Agilent 35670A Dynamic Signal Analyzer

Supplement to Installation, Service and Operator's Guide

35670-90067

The purpose of this supplement is to describe changes to the display of the Agilent 35670A. These changes apply only to instruments with a serial number higher than MY42506200 made after December 2002.

Figure 1 Rear panel

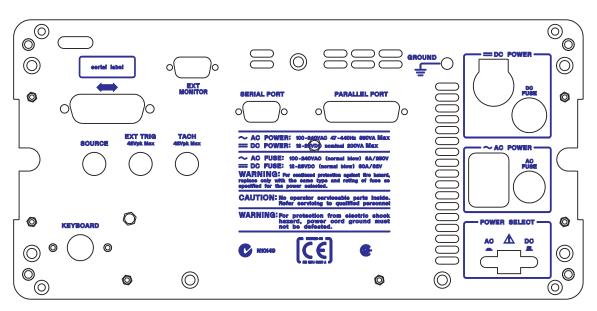
The illustration below shows the new rear panel. The only change is in the location of the external monitor connection. This is the only place in this supplement that shows the new rear panel unless a detailed illustration is required.

Figure 3 Power cables

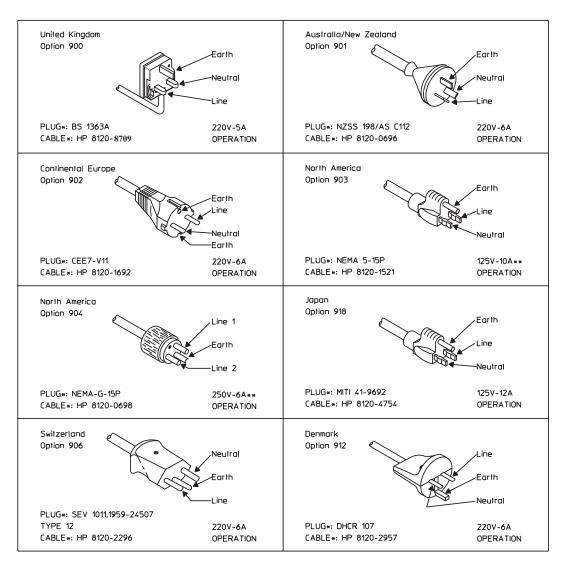
New power cable illustration shows new number for United Kingdom Option 900 cable.

Figure 5 A17 CPU board test point locator

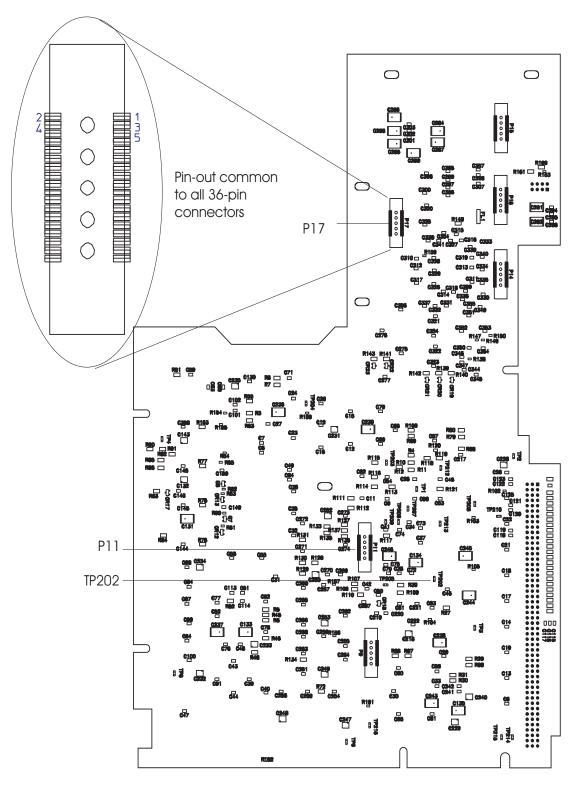
New illustrations for component locators show new test points and new connector locations:

Replace Step 7: Check signals required for power up.

• Using a logic probe, check the following signals.

| Signal Name PVALID RSTn ASn +5V +3.3V C20MHz PASn DSACK1n DSACK0n PRW | Test Location TP202-1 P11-32 P17-27 A17 TP212 A17 TP 216 A17 TP1 TP205 TP207 TP206 TP210 | TTL State High High Toggling High Toggling Toggling Toggling Toggling Toggling | Probable Faulty Assembly A98 Power Supply A17 CPU A17 CPU A98 Power Supply A17 A17 A17 A17 A17 A17 |

Figure 6 A17 CPU board connector locator, component side

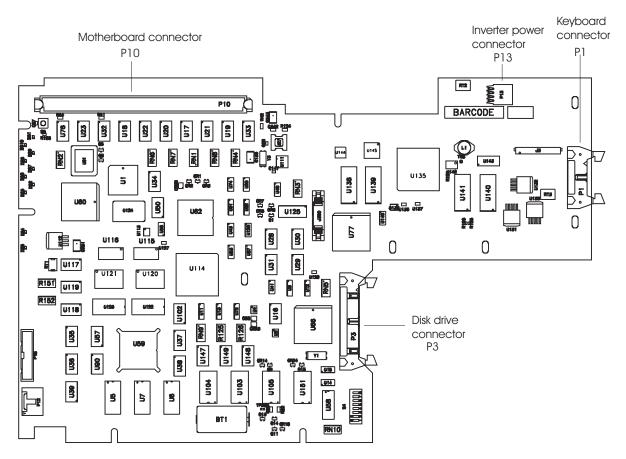
The illustration for component locator shows new connector locations.

Step 5: Replace the bullet concerning reconnecting assemblies:

- Reconnect one assembly at a time in the following order:
 - **1** A17 CPU (A17 P10 to A99 J7)
 - **2** A102 Power Inverter (cable to A17 P13)
 - **3** A11 Keyboard Controller (Cable to A17 P1)
 - 4 A100 Disk Drive (cable to A17 P3)

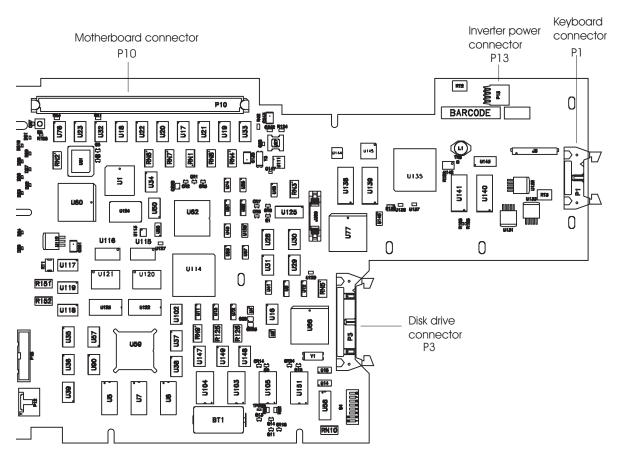
Step 1: Disregard references to Memory Assembly and incorporate the related information into A17 CPU.

Step2: Illustration for component locator shows new connector locations

Figure 8 A17 CPU board connector locator, circuit side

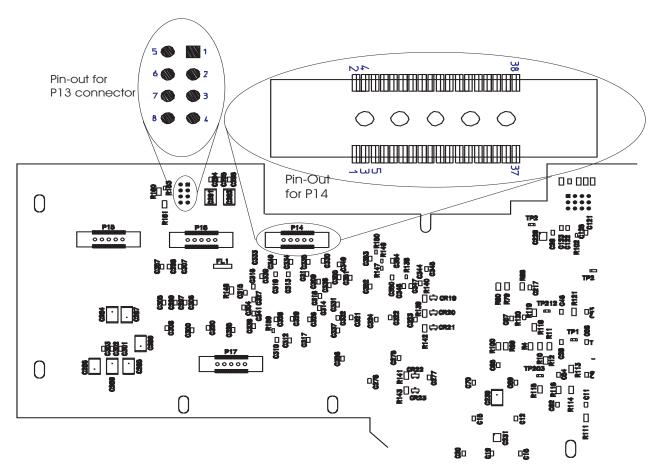
Replace entire section

Use this test to isolate display failures to the A101 Display assembly, A102 assembly, or the A17 CPU assembly

- Set the power switch to off (0).
- Remove the cable connected to P13 on the A17 assembly.
- Set the power switch to on (|)
- Measure voltage at P13 pin 1 on A17 assembly.
- If voltage is not +5Vdc the A17 board may be faulty.
- Set the power switch to off (0).
- Reconnect the cable to P13.
- Set the power switch to on (|).
- Measure voltage at A17 P13 pin 1.
- If voltage is not +5Vdc the power inverter assembly may be faulty.
- If display backlight lamps do not light up, one or both of the lamps may be faulty.
- If lamps are replaced and still do not light up, the power inverter may be faulty.
- ✓ Step 2. Check the CPU signals on the Display assembly.
- Set the power switch to on (|).
- Using a logic probe check that the following TTL signals are toggling:

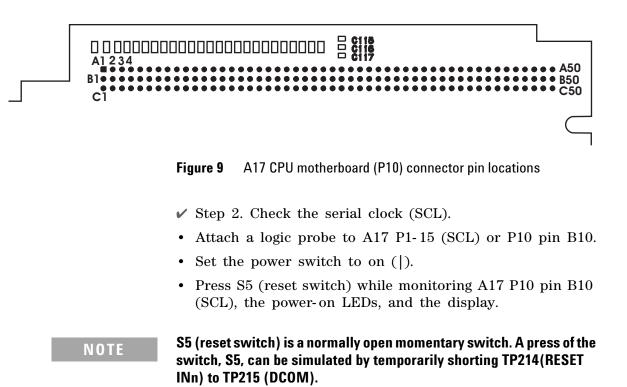
A new illustration above step 2 shows new connector pin-outs:

Figure 12 Battery location

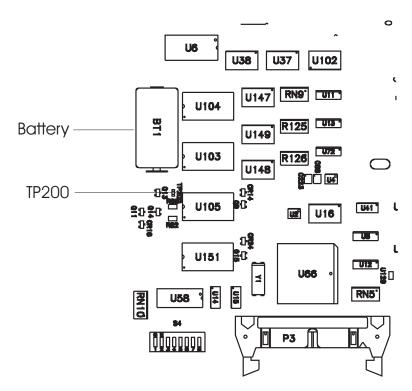
Replace the last five bulleted items:

- If the date is 01-01-01, the battery-backed-up memory is functioning correctly. Enter the current date. Go to page 4-13, "To perform self tests," to continue troubleshooting.
- Set power switch to off (O)
- Check that the voltage at TP200 is 2.6Vdc to 3.1Vdc.
- If the voltage is correct, the memory is probably faulty.
- If the voltage is incorrect, replace the battery BT1.

Figure 13 Location of U111

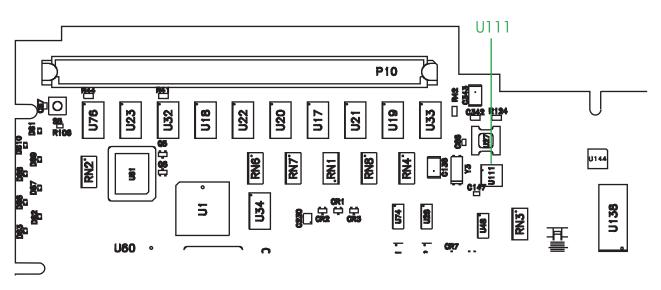
The EEPROM is now U111 on the A17 CPU assembly.

Figure 14 Disconnect the cables from A17

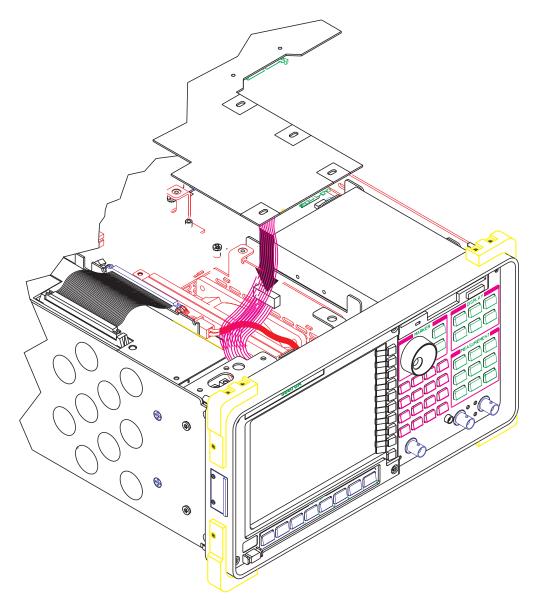
New illustration in step 3 showing an additional cable:

Figure 15 Assemblies

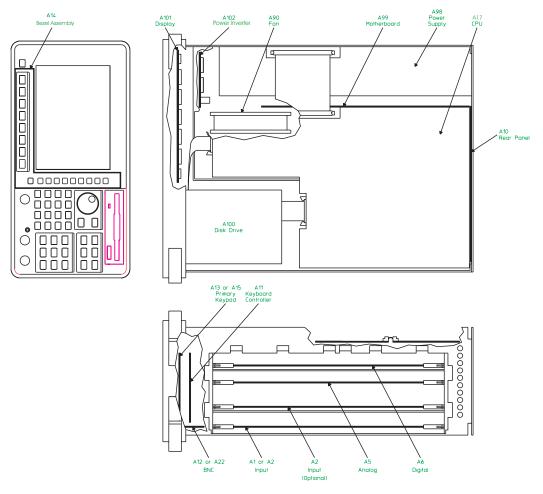
Reference designator A17 replaces A7, A8 and A9. There is also a replacement motherboard, bezel assembly, display assembly and DC-DC converter assembly.

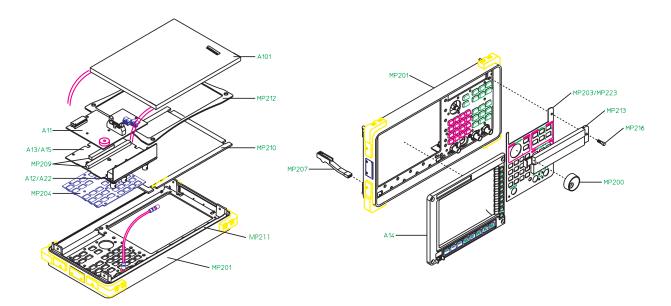
Three parts have been replaced and a new one added:

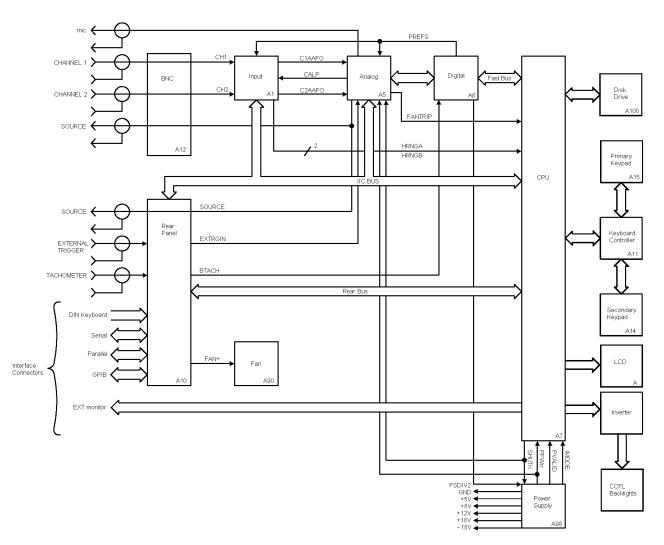
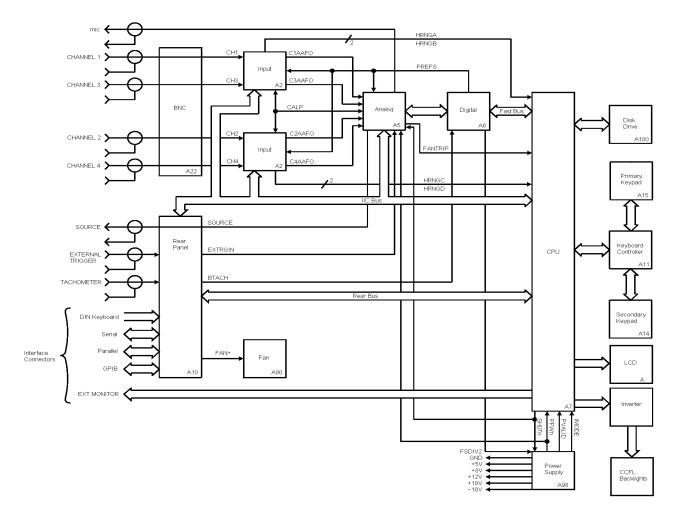
The Memory and NVRAM assemblies are now incorporated into the CPU assembly. The additional NVRAM option assembly is now standard and consolidated onto the CPU assembly.

The DC-DC Converter has been replaced with a Power Inverter which generates the display backlight voltage.

Figure 19 A17 CPU Block Diagram

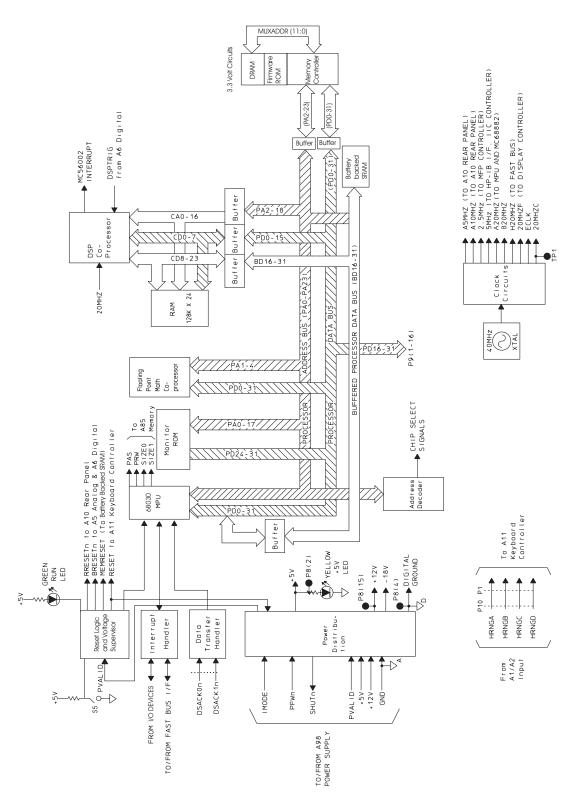
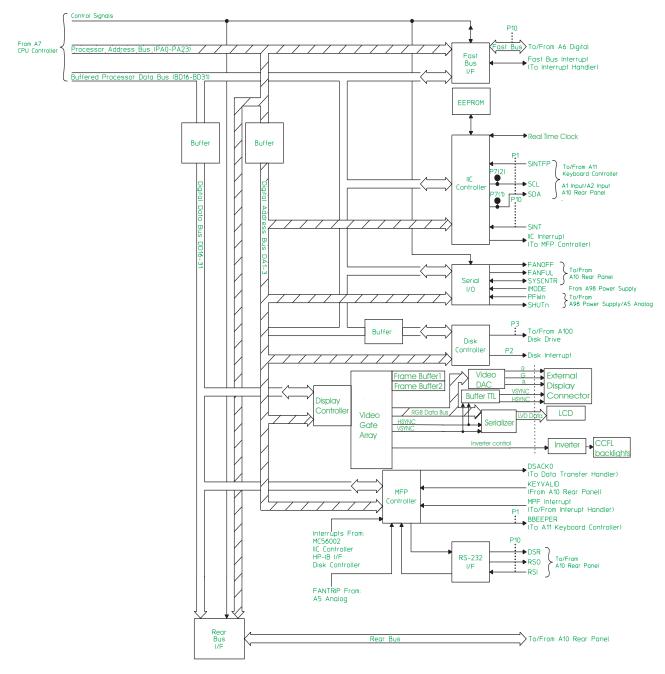
This is now the A17 CPU. Delete all references to A8 memory and A9 NVRAM as separate assemblies since they are now incorporated on the CPU board.

The Math Co-processor is 20 MHz rather than 40 MHz (error in previous documentation).

The 40 MHz oscillator is now a precision clock oscillator and is no longer adjustable.

Figure 21 Reset logic

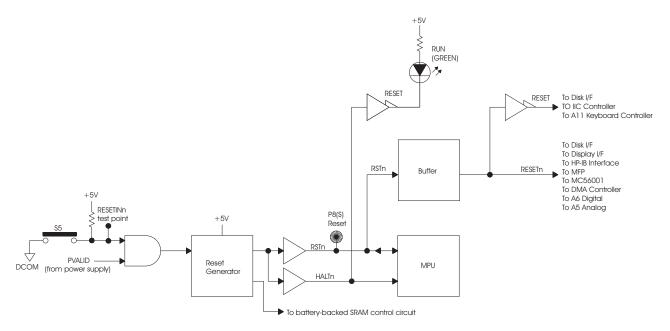
Reset logic all references to S2 are changed to S5 and there is a new block diagram.
